File 1991-0048

Name: Colony Park - Final Plan/Plat-Vac. of ROW -Cider Mill

TITLE HEADING: FINAL PLAN/PLAT & ROW VACATION

ACTIVITY: Request for a Final Plan and Plat for Colony Park and Vacation of Cedar Mill Road right-of-way

CIDER MILL ROAD PLAN AND PROFILE

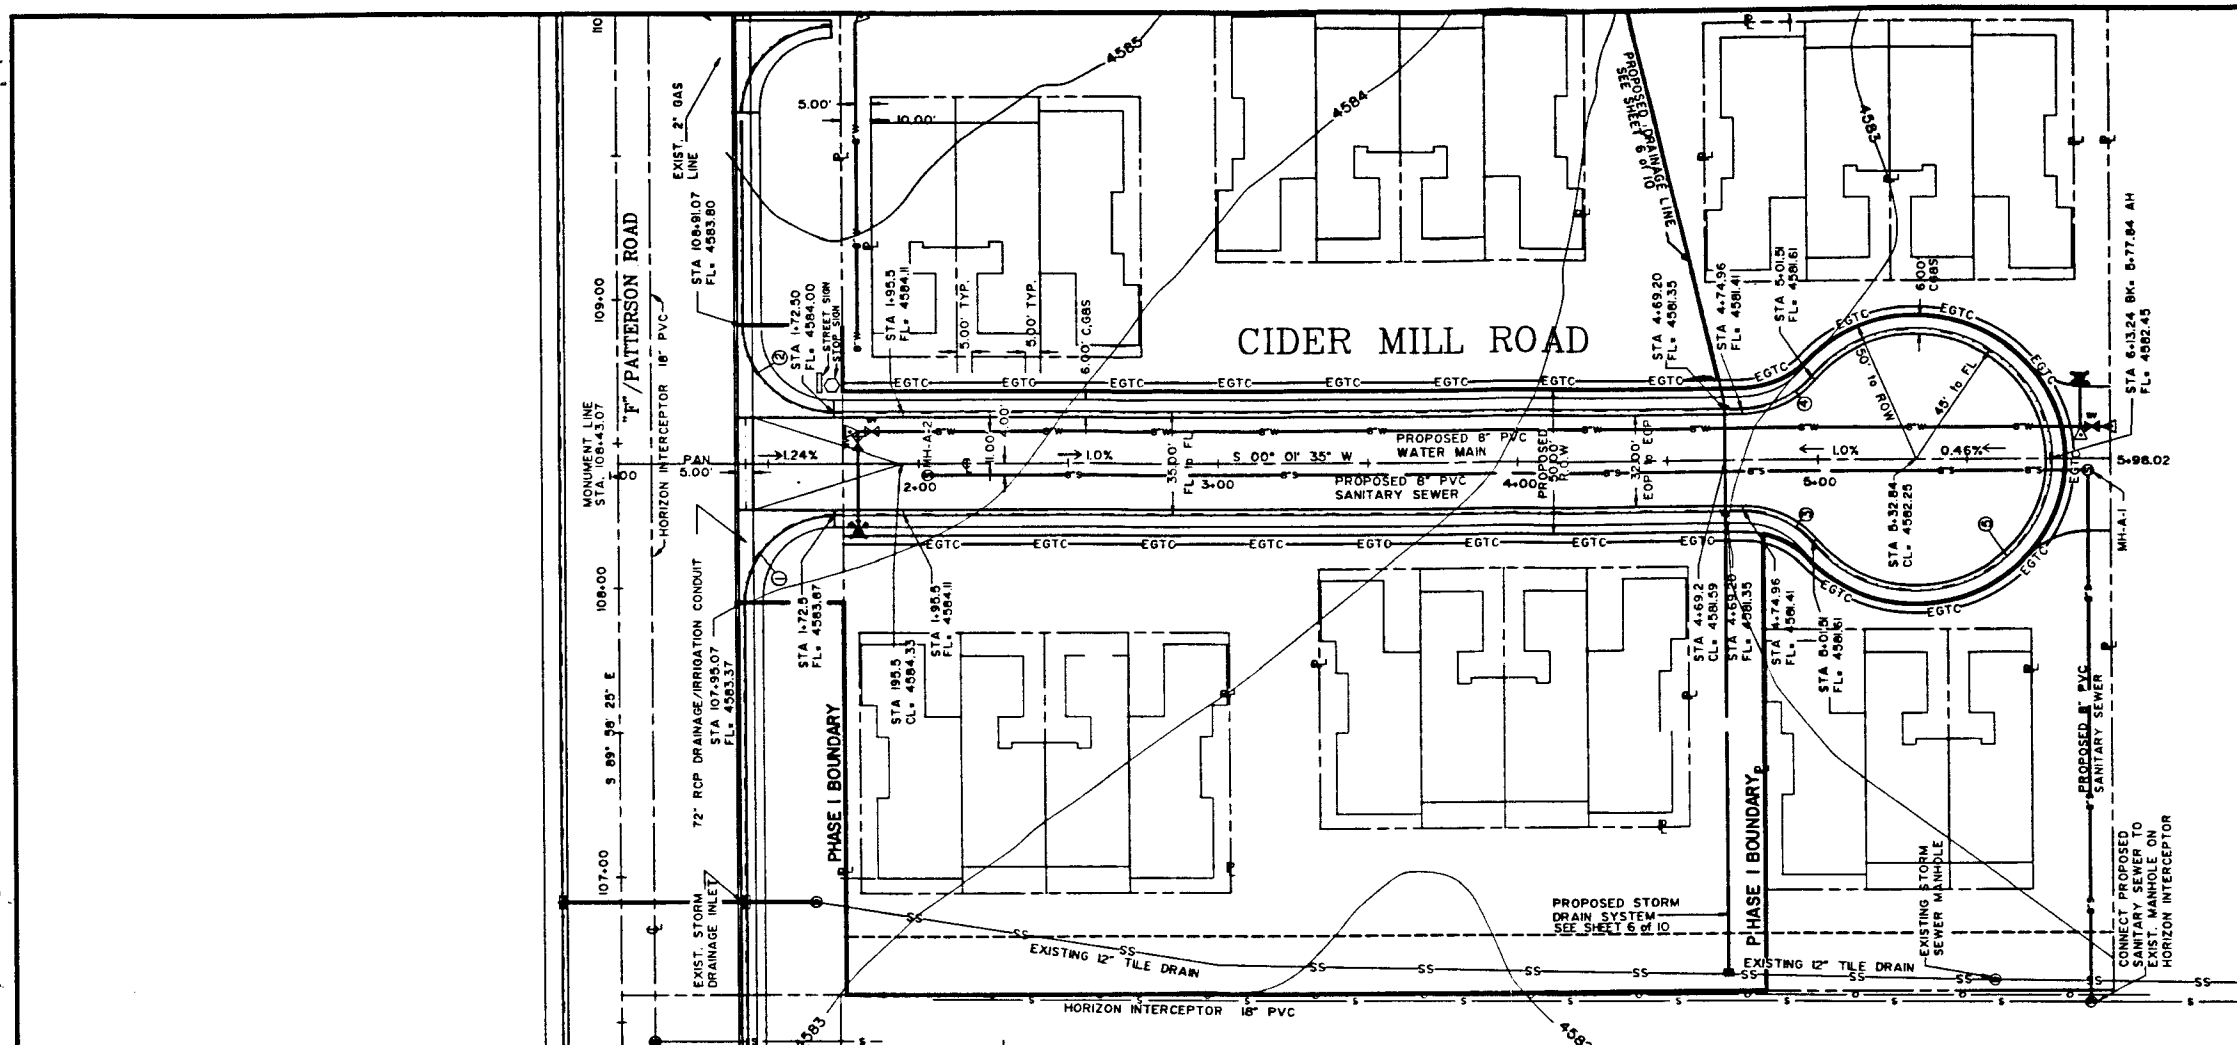
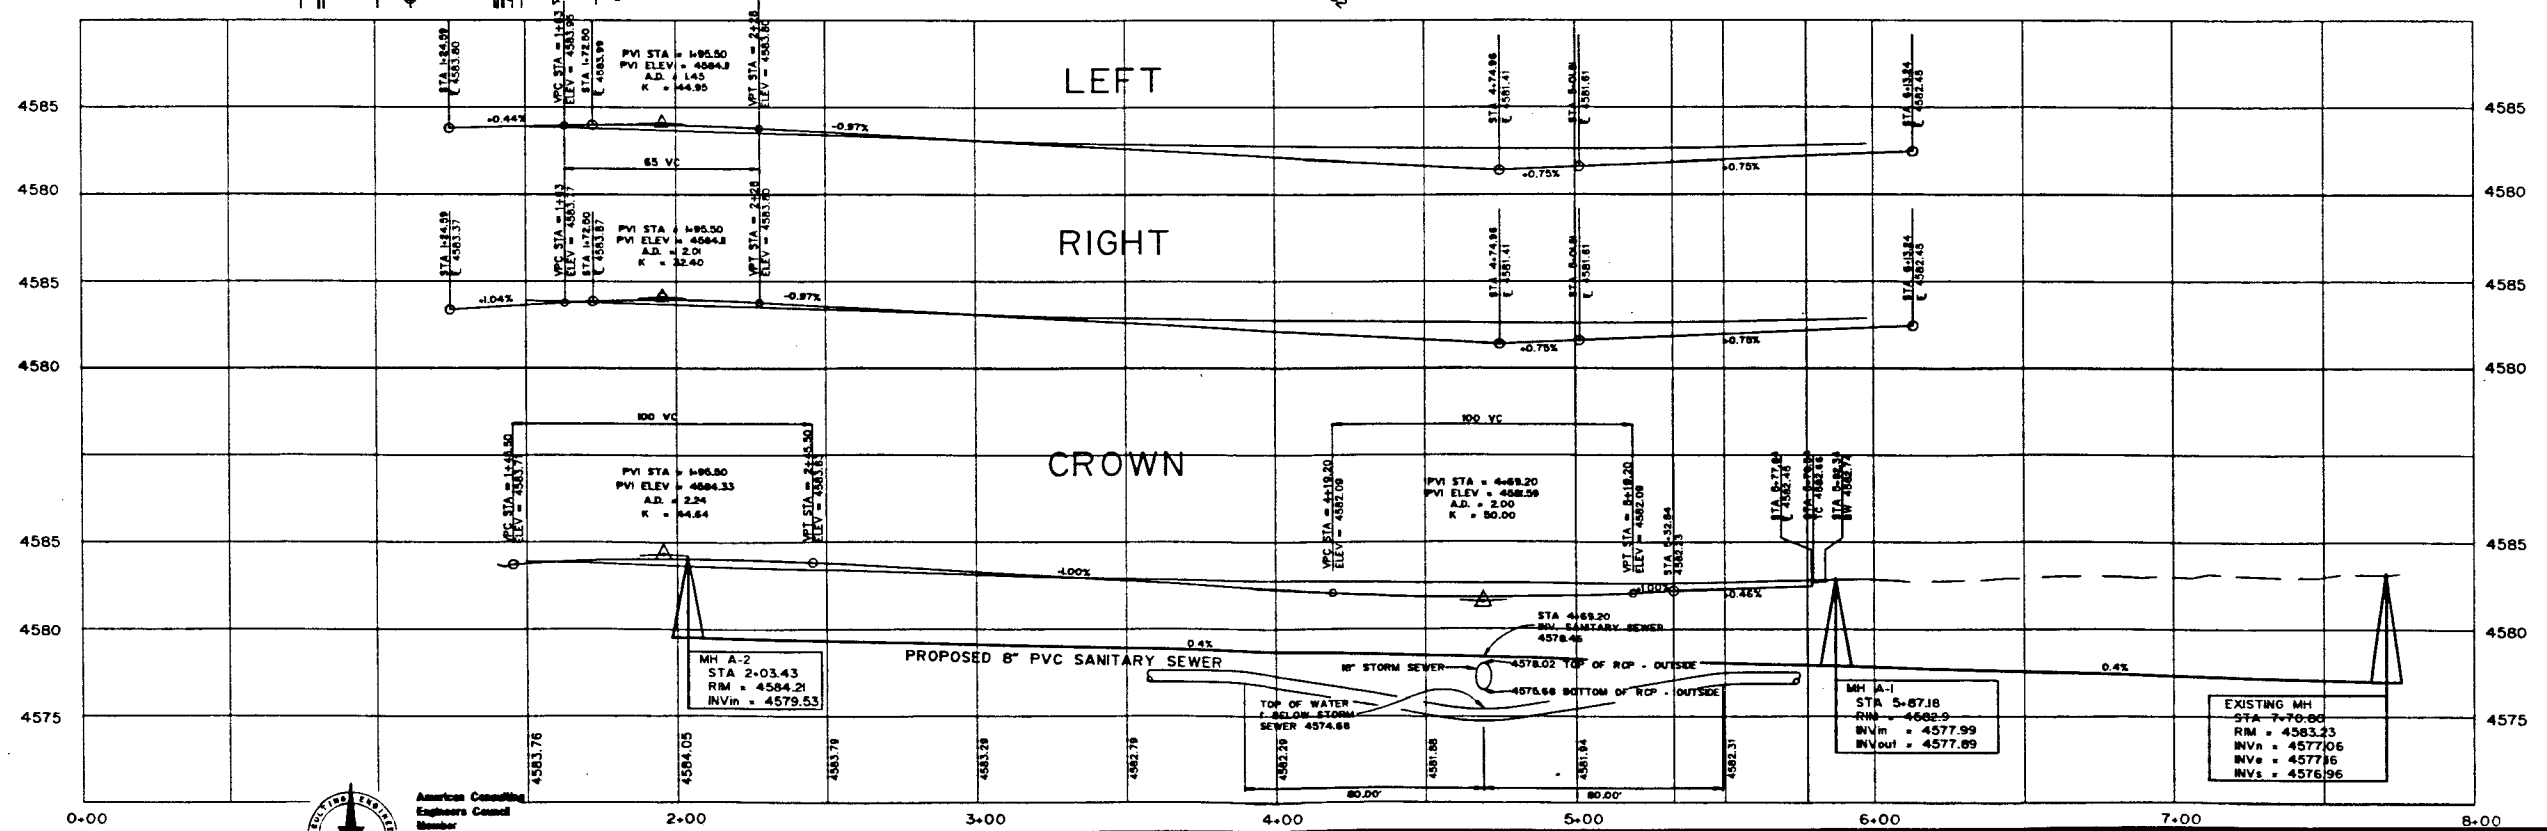
Show street light locations on Utility Composite and street plans.

1. Developer understands a speed limit and Dead-End sign will be required on Cider Mill Road.
2. Street light locations will be shown on the utility composite and street plans.
3. The proposed fence in the R.O.W. will be placed 20' behind the curb line which will completely eliminate the sight distance issue relative to the fence.

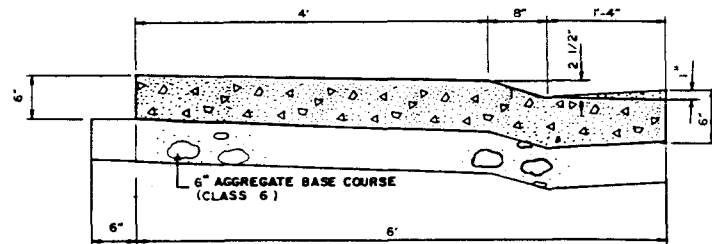
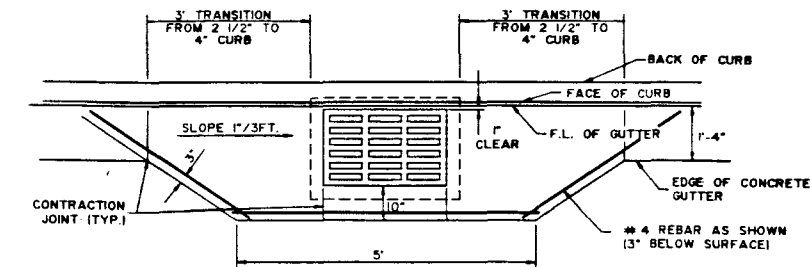
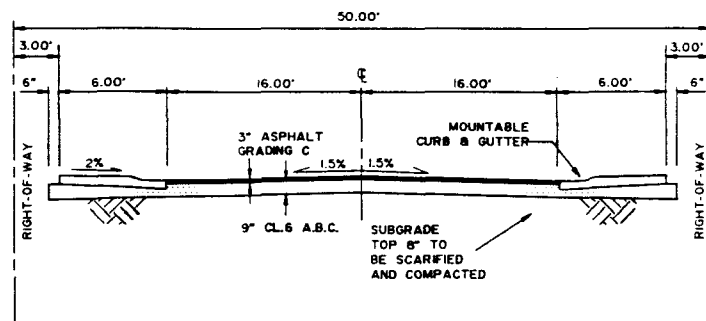
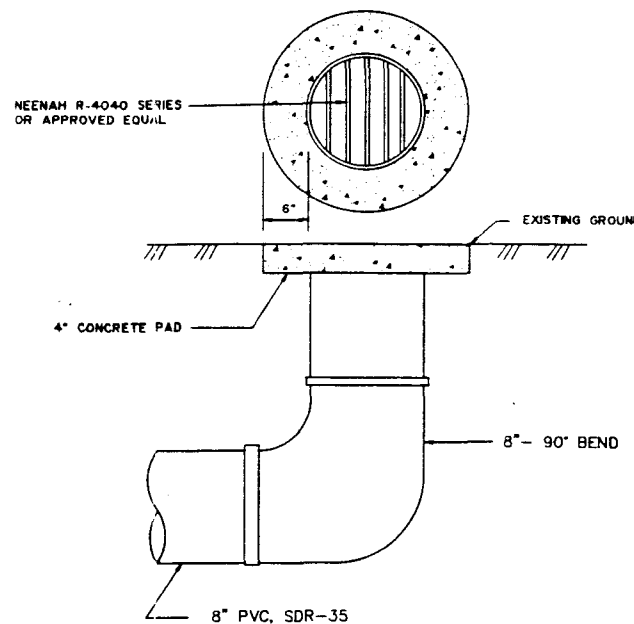
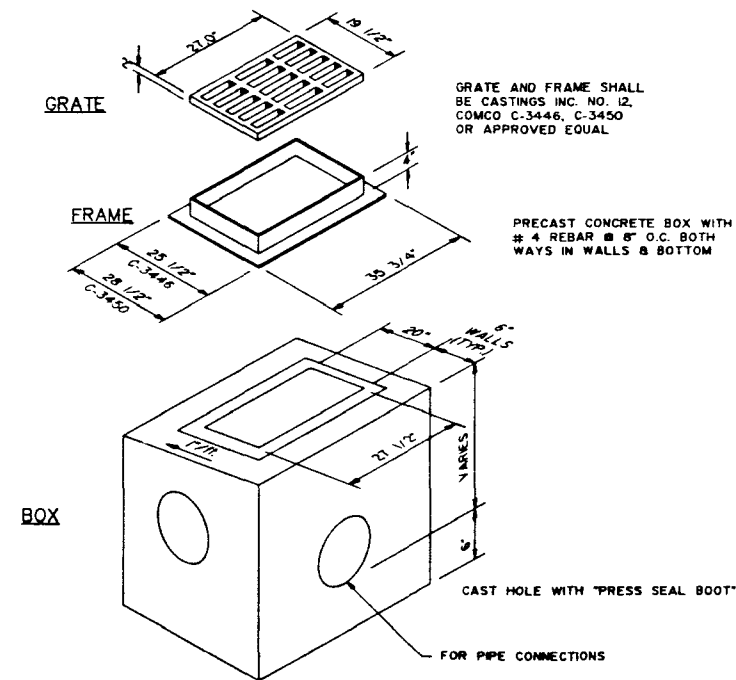
2. On Sheet 10, the handicap ramps shall be constructed in accordance with City standards (see enclosed standard drawing). Side flares on ramps shall have 12:1 maximum slopes.
3. It has not been determined who will be responsible for maintenance of the underground drainage system along the east side of the development, or how to get maintenance equipment to the inlets. It is my understanding that the Grand Junction Drainage District will require that no plantings, structures or obstructions will be allowed in the vicinity of the pipes and inlets east of Cider Mill Road if they are to maintain the system.

4. Additional reinforcing steel will be required (per City standards) at the ends of the concrete V-Pan shown on Sheet 10.
5. The Grand Junction Drainage District has completed installation of the new drainage pipe along the west side of the development. Please verify that the grades and elevations of the proposed drainage system will match the new drainage pipe. Elevations at the connection to the new drainage pipe should be shown on the plans.
6. Furnish to me three sets of drawings with Engineers Stamp and Signature and provide space on the drawings for Approval by the City Engineer. We will retain 2 sets of approved drawings.

COLONY PARK, FILING NO. 2: A REPLAT OF A PORTION OF COLONY PARK, FILING NO. 1, AND A PORTION OF THAT PARCEL DESCRIBED IN DOCUMENT RECORDED IN BOOK 1814, PAGE 405, AND COLONY PARK, PHASE I, FILING 2, SECTION 10, T.1 S., R.1 W., UTE MERIDIAN

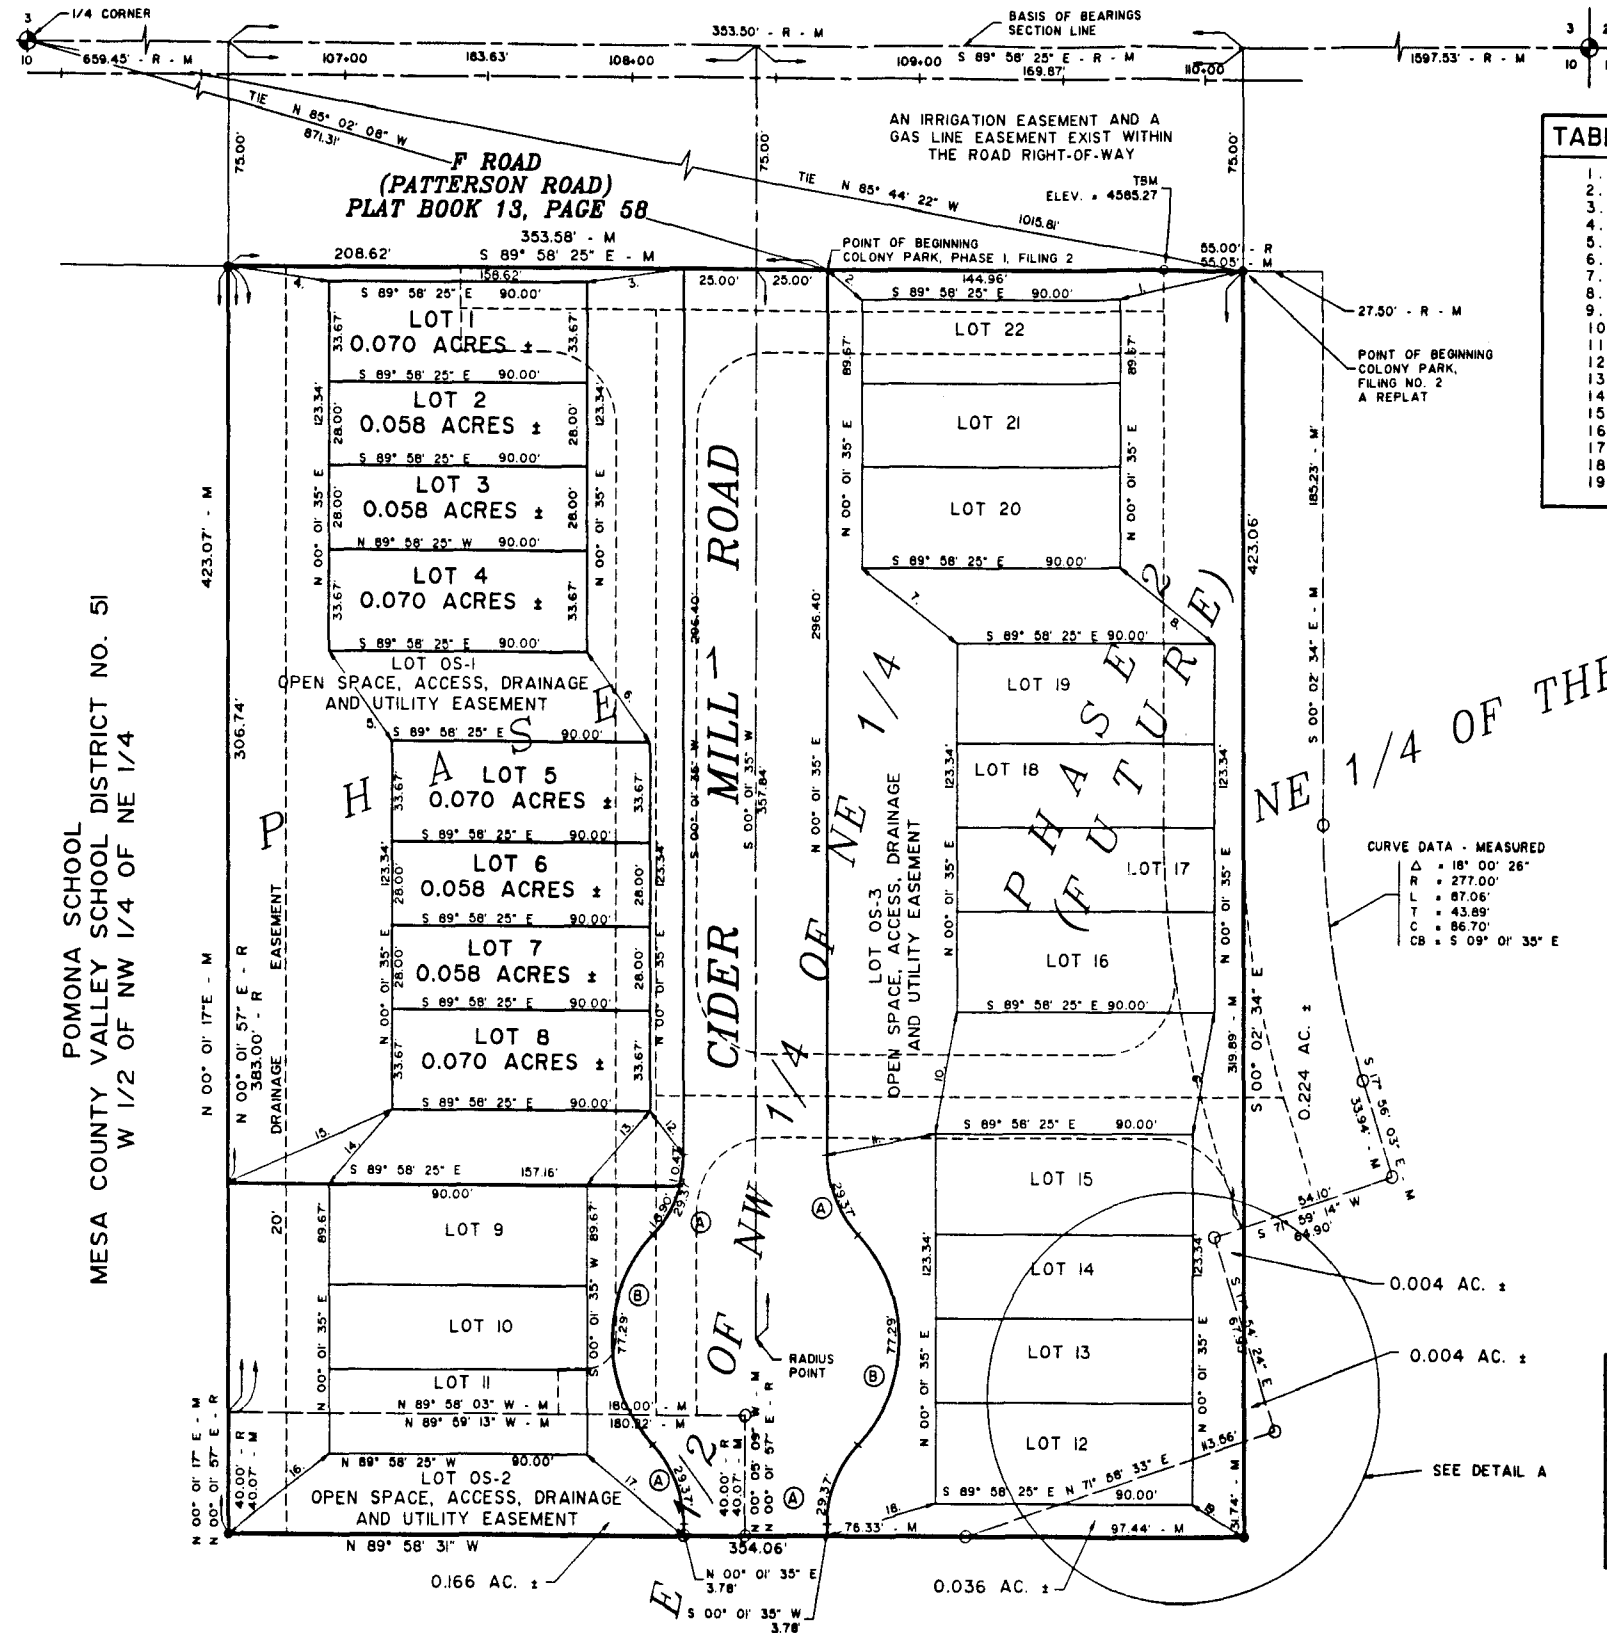
1. The plat should be cleaned up to delete extraneous verbage. Since some previous recorded easements will be vacated via the replat they should not be shown on the final plat (dashed lines).
2. No objection to fence in R.O.W. for Patterson Road as long as it lines up with Pomona School. Fence maintenance of area between fence and curb is the responsibility of this development.
3. Developer is responsible for closing the existing curb cut for Cider Mill Road.
4. We will need to review deeds for realignment of property lines.
5. Recommend the developer contact the School District to discuss the possibility of a direct access to the school grounds from this project.
6. Show & lable future extension of cul-de-sac on the site plan as well as plat.
7. Driveway from Unit 8A exits on to Phase 2. Phase line should be angled on easement provided.

1. Mr. Jim Langford of Banner Associates will be meeting with you prior to the hearing to delete all extraneous verbage and lines not needed on the final plat.
